**REMARKS**

This Amendment is filed in response to the Office Action dated August 28, 2002. A petition for a two-month extension of time is enclosed. Claims 1-7 and 9-20 are pending in this application. Claims 8 and 9 are cancelled, without prejudice.

Serial No. 09/617,459

FIG. 4

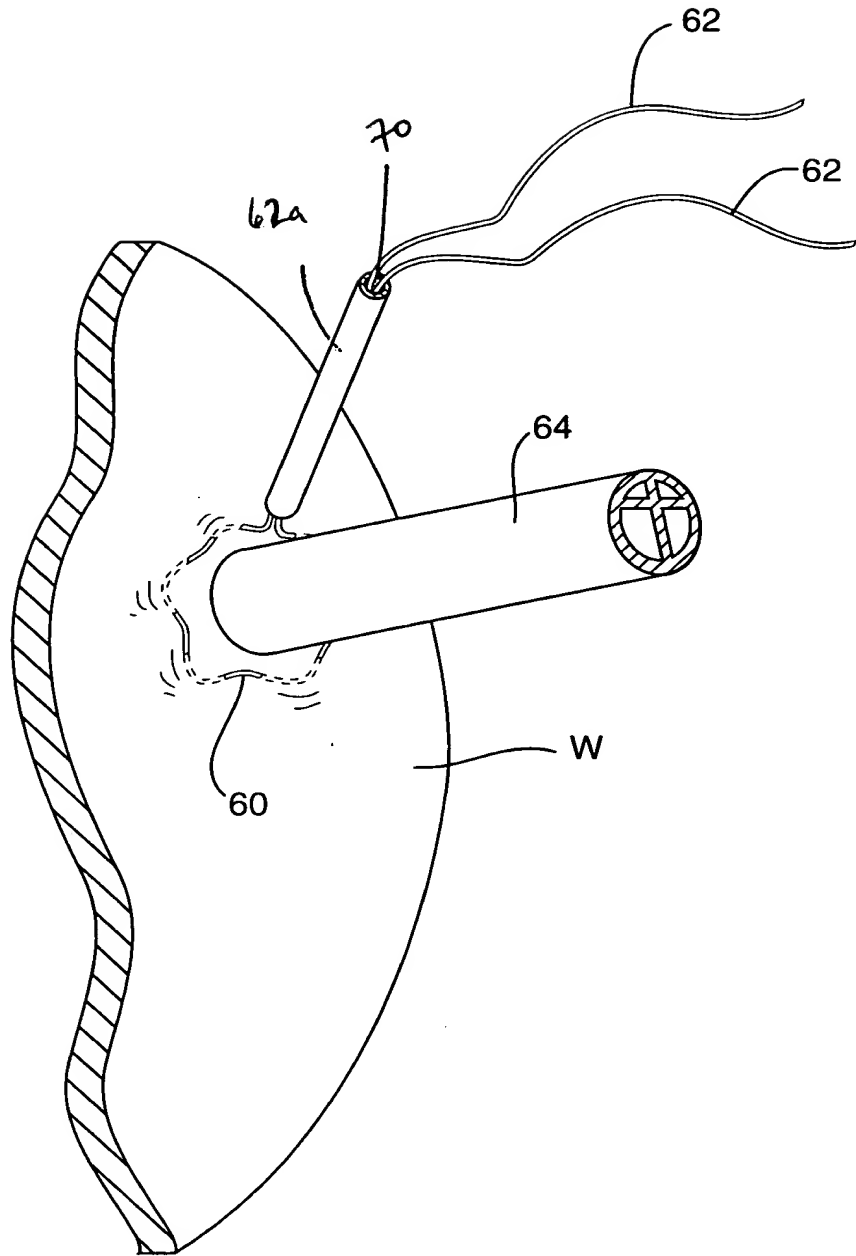
The Examiner objected to the drawings under 37 C.F.R. § 1.83(a) as the stylet and shaping mechanism are not shown in the figures. Applicants have cancelled claims 8 and 9 thereby rendering the objection moot. With regard to the blood flow device, claim 20 has been amended to replace "blood flow device" with "arterial return cannula", a term that has support throughout the specification. claims 10 and 16, the same have been amended in accordance with the Examiner's assumptions. The Examiner objected to the drawings as failing to comply with 37 C.F.R. § 1.84(p)(5) because reference numeral 116 is included in drawing 8, but is not described in the specification. Applicants have amended the specification at page 19, last paragraph to include a reference to "opening 116".

Further, Applicants have amended Figure 4 to include reference numerals 62a and 70 to correct an error located by the Examiner. A copy of the changes is indicated in red ink on an enclosed copy of Figure 4. Applicants will submit a formal drawing to make the proposed changes to Figure 4.

A preferred technique of positioning cardioplegia catheter 20 in the ascending aorta is shown in Figures 4-6. In this technique, a purse-string suture 60 is placed in the left atrial wall W around the intended site of catheter introduction, as shown in Figure 4. Suture 60 may be placed using well-known techniques, and is preferably placed using thoracoscopic instruments introduced through small incisions, trocar sleeves or other intercostal access ports not requiring a gross thoracotomy. The left atrium may be accessed via access ports in the 3rd, 4th or 5th intercostal spaces on the right lateral or right anterior side of the chest. If desired, the heart may be repositioned within the chest to improve access using thoracoscopic retraction instruments introduced through access ports between the ribs. Once purse-string suture 60 has been placed in wall W, a small incision or puncture P is formed in wall W so as to be encircled by suture 60, and a flow-directed catheter 64, shown in Figure 5, is inserted through puncture P. The free ends 62 of suture 60 may then be tensioned so as to form a seal between wall W and the outer wall of flow-directed catheter 64. Preferably, a suture tensioner 66 is used to maintain tension on suture ends 62, which may consist of a tube 68 62a having an inner lumen 70 through which ends 62 may be passed. Lumen 70 is dimensioned frictionally engage suture ends 62 so as to maintain adequate tension on suture S to create a hemostatic seal around catheter 64.
